G.993.5
Amendment 2
(10/2012)

Self-FEXT cancellation (vectoring) for use with
VDSL2 transceivers

Amendment 2

Recommendation ITU-T G.993.5 (2010) –
Amendment 2

Figure 8-1 – Timing diagram of the pilot sequence update command and response

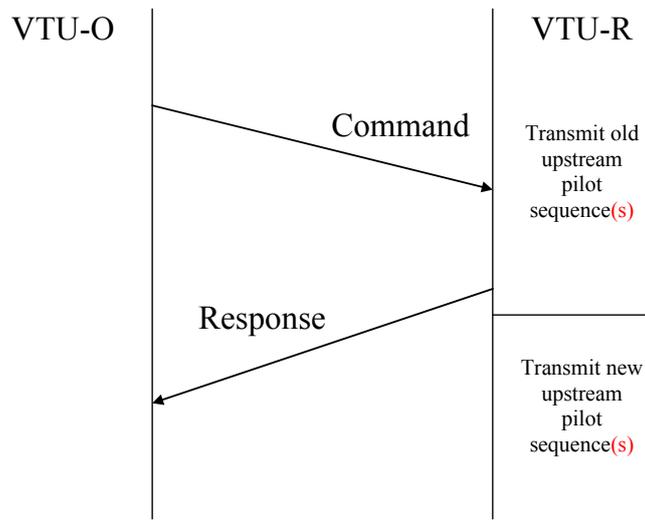
If the pilot sequence update command updates the upstream pilot sequence(s), the VTU-R shall apply the change only after sending the ACK message. If interruption of the current pilot sequence(s) is allowed, the update should occur as soon as possible, and shall occur within 200 ms after sending the ACK message.

The timing diagram of the pilot sequence eoc command and response is shown in Figure 8-1.
